Subject: Response by Permittee to Fish and Wildlife Service Letter of 22 December 2016,
Draft TPDES Permit for City of Dripping Springs

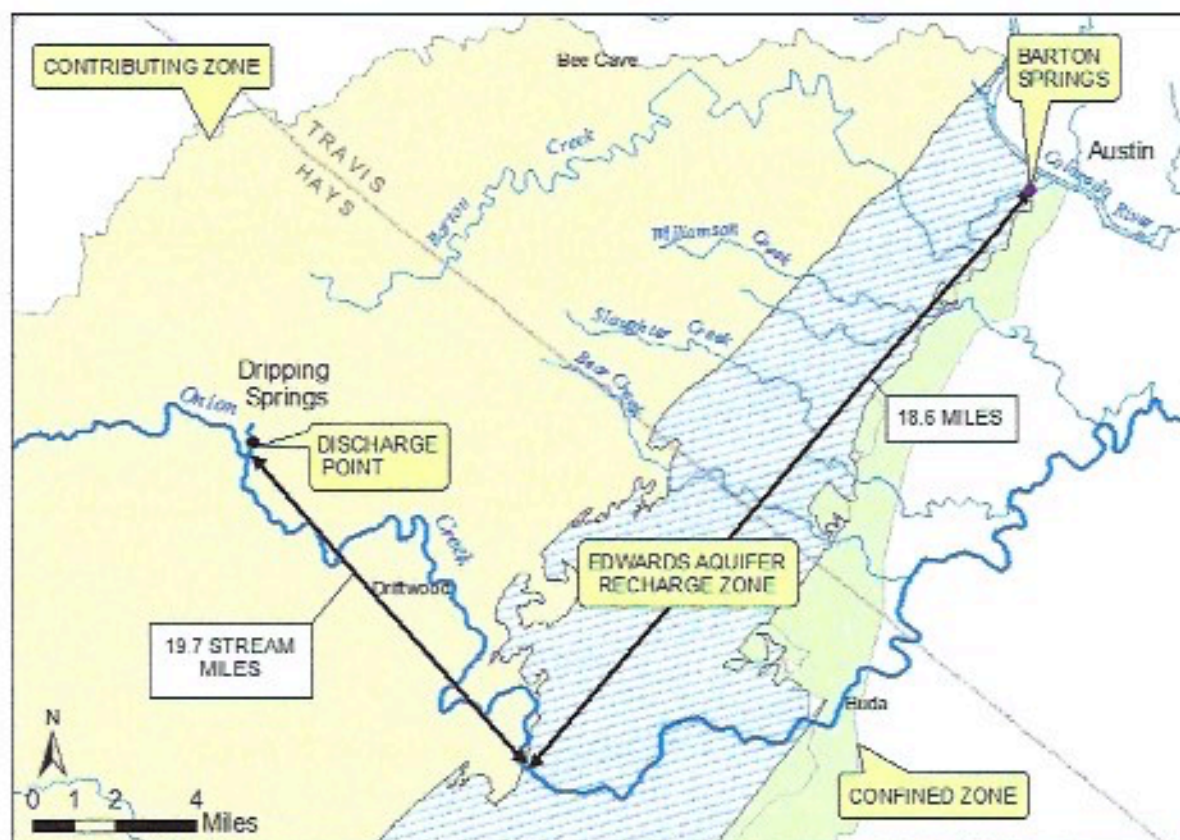
It is unclear which version of modeling results the FWS discusses. The revised modeling work concluded that effects upon algal growth were restricted spatially to a reach of approximately 2.5 - 3 miles immediately below the discharge point, and that these effects would raise benthic algal growth to a mesotrophic biomass level. This should be contrasted with the initial modeling work that suggests that impacts on algal growth may be seen as far as 9 – 12 miles downstream of the discharge point.

As a final comment regarding the water quality aspects of the proposed TPDES discharge from CDS, it has to be recognized that there is considerable distance between the proposed discharge point and the Edwards Aquifer recharge zone on Onion Creek. The best available mapping,

as shown in the figure above, indicates that the discharge point will be located approximately 19.7 stream miles above the upper edge of the recharge zone, then continue for an additional 9 miles to the lower end of the recharge zone. Thus, regarding the composition of the effluent discharge, it must travel a substantial distance to arrive at the recharge zone, and along the way, natural degradation processes including settling, aeration, biological uptake, and photolysis will take place, as well as dilution with ambient water. At the point of recharge to the aquifer, the effluent would likely not be discernible from typical ambient water. Once the Onion Creek flow enters the aquifer, its precise path is not known, but a direct straight-line route would require travel over an additional 18.6 miles to reach Barton Springs. Along this route, it will be subject to additional dilution from groundwater resident in the aquifer, and from recharge from Bear Creek, Slaughter Creek, Williamson Creek, and Barton Creek. Given all of the preceding factors, it can only be reasonably concluded that the proposed effluent discharge will always be undetectable at Barton Springs.

There is the issue of substantial distance between the proposed discharge point and the recharge zone, as well as the distance from the recharge zone to Barton Springs. The available mapping for the Edwards Aquifer recharge zone (see Figure) indicates that the zone is crossed by Onion Creek approximately 20 stream miles below the proposed effluent discharge point. At low to normal flow conditions in Onion Creek, if it is assumed that a typical ambient flow velocity is approximately 0.1 ft/sec, it would take 293 hours, or 12 days, for any effluent flow from the treatment plant outfall to reach the upper edge of the recharge zone. As the mixture of effluent and stream baseflow moves along the creek, it is subject to many natural processes that will effect constituent concentrations, including oxidation, sedimentation, biological uptake, and photolysis. As explained in the preceding comments, the proposed effluent discharge will be of extremely high quality, with very low concentrations of nutrients and oxygen-demanding materials, and therefore, at the point of recharge, any effluent remaining will likely be undetectable from ambient baseflow conditions. As stated above, the distance from the recharge point to Barton Springs is at least 18.6 miles.
